## TECHNICAL SERVICE BULLETIN

Reference Number(s): NTB02-044, Date of Issue: April 10, 2002

NISSAN: 2000-2002 Frontier, Xterra

COOLANT LEAK FROM INTAKE MANIFOLD WATER OUTLET

[Fig. 1: Intake Manifold Water Outlet](#)

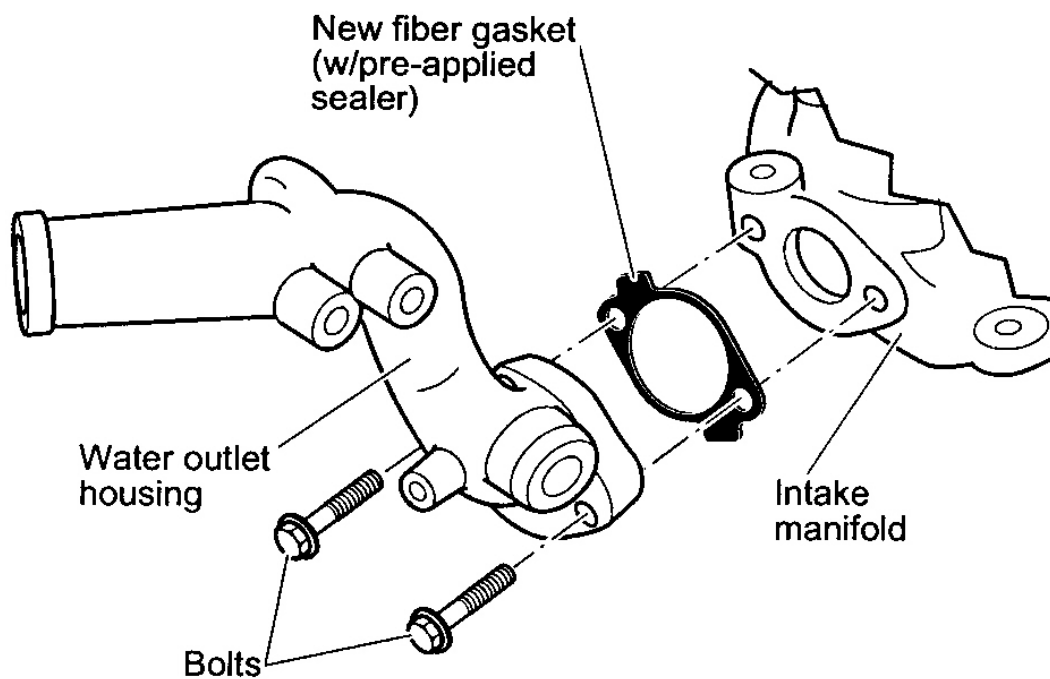
The cause may be coolant leaking between the water outlet housing and intake manifold sealing surfaces (see **Fig. 1**). Refer to the **SERVICE PROCEDURE** to resolve this incident, should it occur.

Install the new fiber gasket (refer to the [PARTS INFORMATION](#) section) between the water outlet housing and intake manifold as follows:
